SUBJECT: 3<sup>rd</sup> COMPLETENESS REVIEW OF A SHORT PLAT FILE NO. SUB15-00016 FOR A  
VACANT PARCEL IN THE HOLMES POINT AREA; PARCEL: 2796700115

This is the third completeness review of the Up-Lake Short Plat application. Unfortunately, it is still incomplete.

**Subject:** Up Lake Short Plat (SUB15-00016) – Preliminary Stormwater Review Comments (formerly called Antemie/Shoreline/MV)

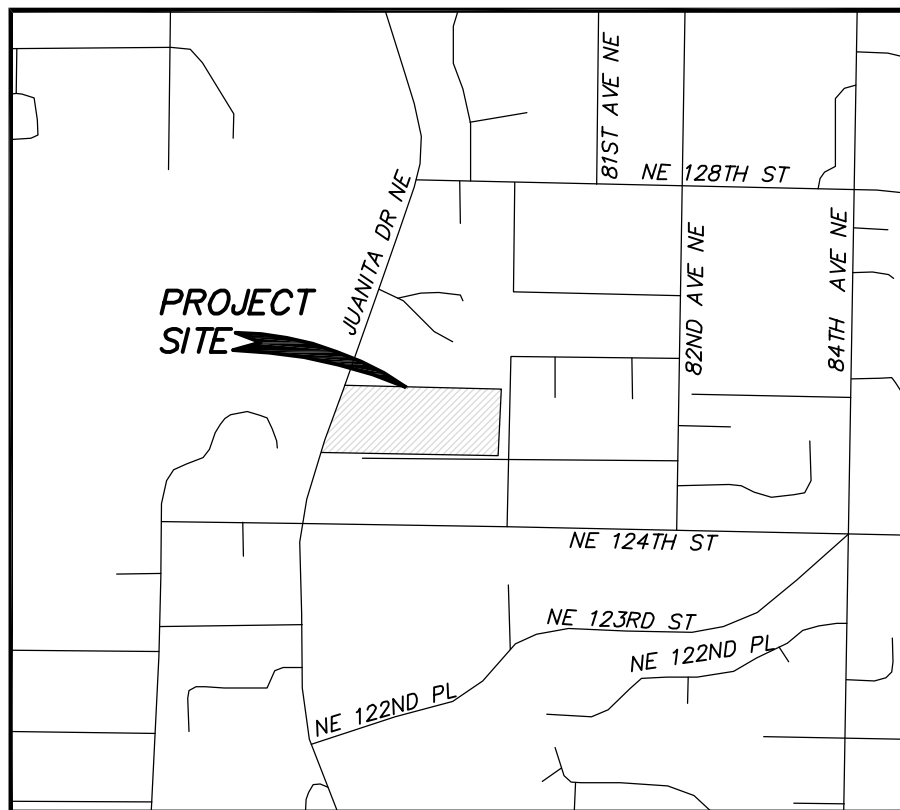
B. The proposed storm conveyance from each home must be shown on the plans.
